# UNITED STATES PATENT AND TRADEMARK OFFICE

APPLICATION NO.	FILING DATE	FIRST NAMED INVENTOR	ATTORNEY DOCKET NO.	CONFIRMATION NO.
10/058,958	01/28/2002	Edward R. diGirolamo	4782-022	4628

<b>Office Action Summary</b>	<b>Application No.</b> 10/058,958	<b>Applicant(s)</b> DIGIROLAMO ET AL. 	
	<b>Examiner</b> Yvonne M. Horton	<b>Art Unit</b> 3635

## **DETAILED ACTION**

EXHIBIT

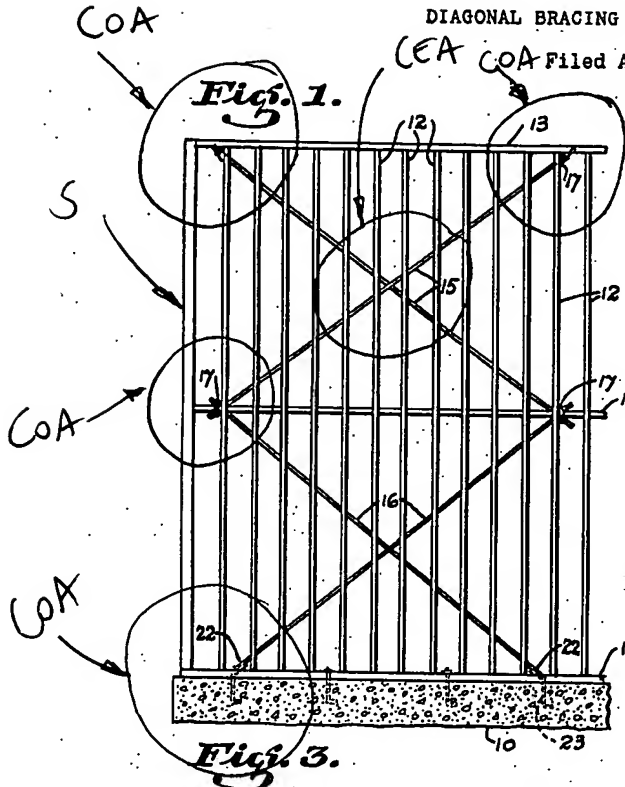
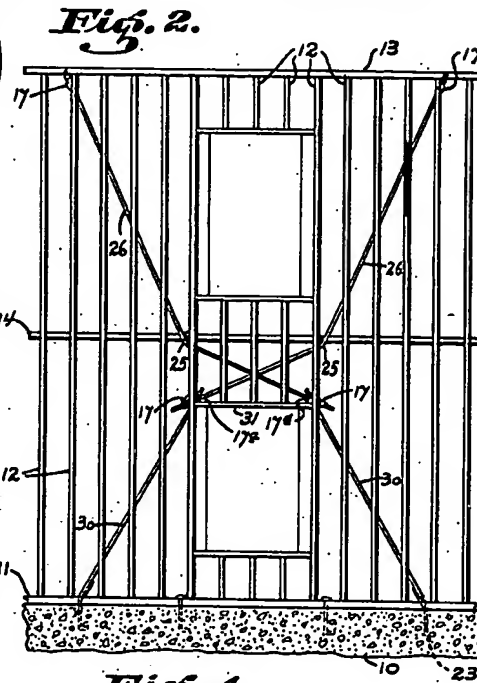
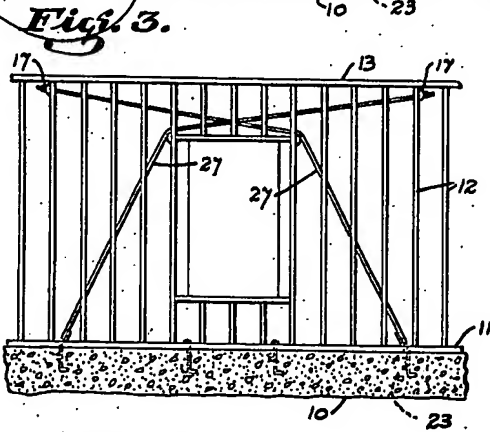
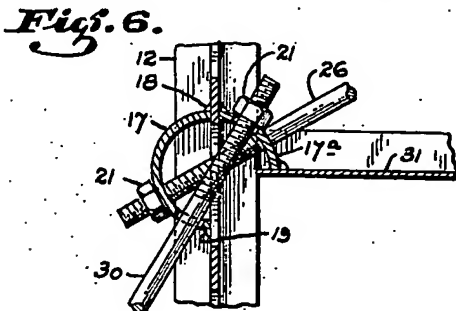
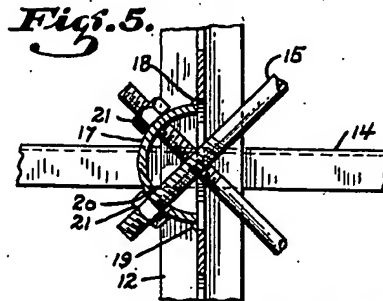
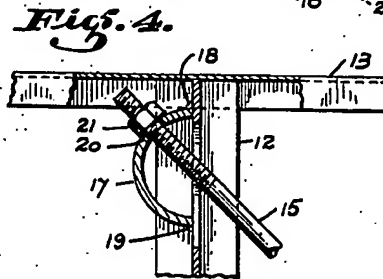
Claims 1,2,4-10,12 and 13 are rejected under 35 U.S.C. 102(b) as being anticipated by US Patent #2,126,511 to SOULE'. SOULE' discloses a wall structure including a pair of opposed members (11,13,14) having a plurality of studs (12) spaced therebetween; wherein the studs (12) have openings (page 1, column 2, lines 25-30) therein for receipt of diagonal members (15,16) therethrough. Regarding claim 2, the wall structure includes corner areas (COA) wherein the diagonal members (15,16) are connected therebetween, see the marked attachment. In reference to claims 4 and 5, the diagonal members (15,16) are elongate rods connected between the corner areas (COA), page 2, column 1, line 9. Regarding claim 6, there are four corner areas (COA) and a pair of diagonal rods (15,16) that extend through the openings. In reference to claim 7, the wall structure further includes a pair of opposing sides (S); however, with only one being shown, and a central area (CEA) wherein the diagonal member (15,16)

extends through the central area (CEA), see the marked attachment. In reference to claim 8, the diagonal braces (15,16) consist of a pair of braces that extend through the openings (page 1, column 2, lines 25-30). Regarding claim 9, the corner areas (COA) are opposed corner areas (COA) and the diagonal members (15,16) are connected thereto by connectors (17). Regarding claims 10 and 12, the brace (15,16) is connected to the connector (17) so as to be in tension through the nut member (21), page 2, column 1, lines 50-61, essentially at all times. In reference to claim 13, the connectors (17) are anchored between a stud (12) and one of the opposed members (11,13,14).

Claims 16-19 and 24 are rejected under 35 U.S.C. 102(b) as being anticipated by US Patent #2,126,511 to SOULE'. SOULE' discloses a wall structure including upper members (13), lower members (11), a plurality of studs (12) spaced therebetween; wherein the studs (12) have openings (page 1, column 2, lines 25-30) therein for receipt of diagonal members (15,16) therethrough and a pair of connectors (17), secured to opposed corner areas (COA), see the marked attachment. In reference to claims 17 and 18, the diagonal members (15,16) are elongate rigid shaft members. Regarding claim 19, the shaft members (15,16) includes opposed threaded ends (30), page 1, column 1, line 43, such that each shaft (15,16) projects through an opening (20) formed within the connector (17) and is securely retained by a retainer (21). In reference to claim 24, the wall structure further includes side members (S) and a central area (CEA) wherein the diagonal members (15,16) extending through the central area (CEA), see the marked attachment.

Claim 25 is rejected under 35 U.S.C. 102(b) as being anticipated by US Patent #2,126,511 to SOULE'. SOULE' discloses a wall structure including a pair of opposed member (S), a series of spaced studs (12) each having openings (page 1, column 2, lines 25-30) for receipt of a diagonal member (15,16) extending therethrough and being connected between corner areas (COA) by connectors (17).

Claim 30 is rejected under 35 U.S.C. 102(b) as being anticipated by US Patent #2,126,511 to SOULE'. SOULE' discloses the use of a wall structure including upper members (13), lower members (11), a plurality of studs (12) spaced therebetween; wherein the studs (12) have openings (page 1, column 2, lines 25-30) therein for receipt of diagonal members (15,16) therethrough and a pair of connectors (17), secured to opposed corner areas (COA), see the marked attachment. The connectors (17) are anchored between a stud (12) and one of the opposed members (11,13,14); wherein the diagonal members or shafts (15,16) include threaded ends (30) page 1, column 1, line 43, such that each shaft (15,16) projects through an opening (20) formed within the connector (17) and is securely retained by a retainer (21).
